DATE: January 12, 2016  
PROJECT No. 3042.05  
PROJECT NAME: Fire Hydrant Replacement - WHI - R.082511.001

### Civil Addendum

**4. Refer to the attached drawings C01, C02, C03, all revision 3, Issued for Addendum, dated, 17-01-16;**

**KEY PLAN**

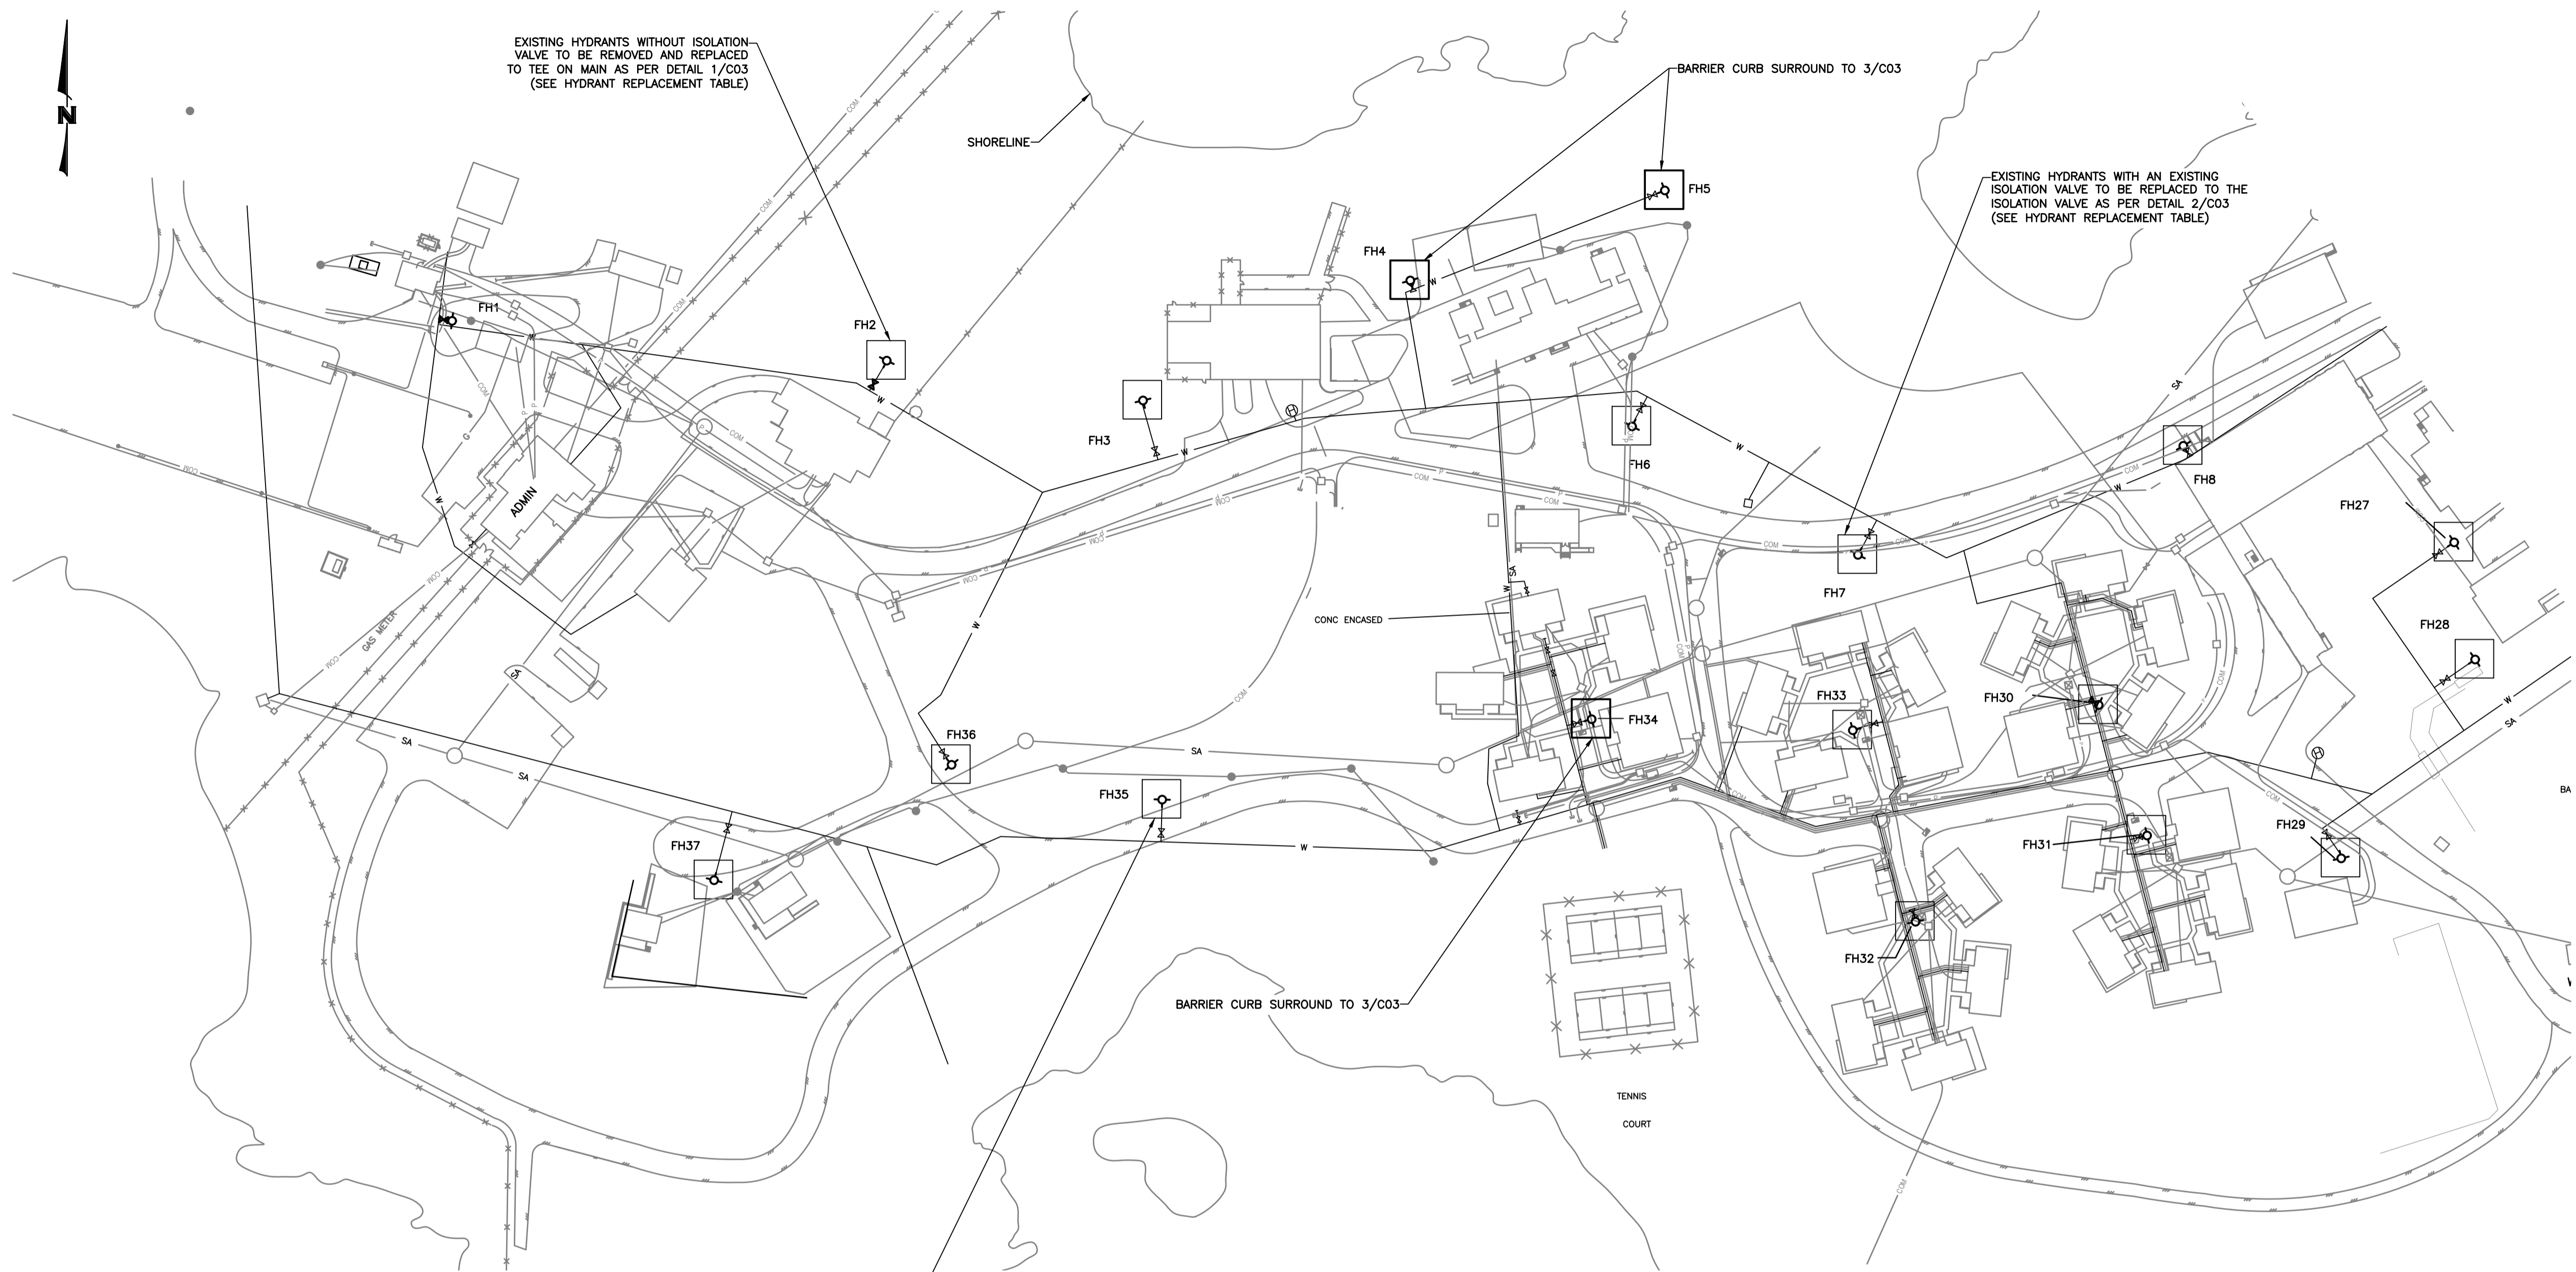
- a. Numbering of the fire hydrants has been revised to match the requirement of the William Head Institute
- b. The tables at the lower left of drawings C02 & C03 have been revised to delete the column "Hydrant & Valve Box".
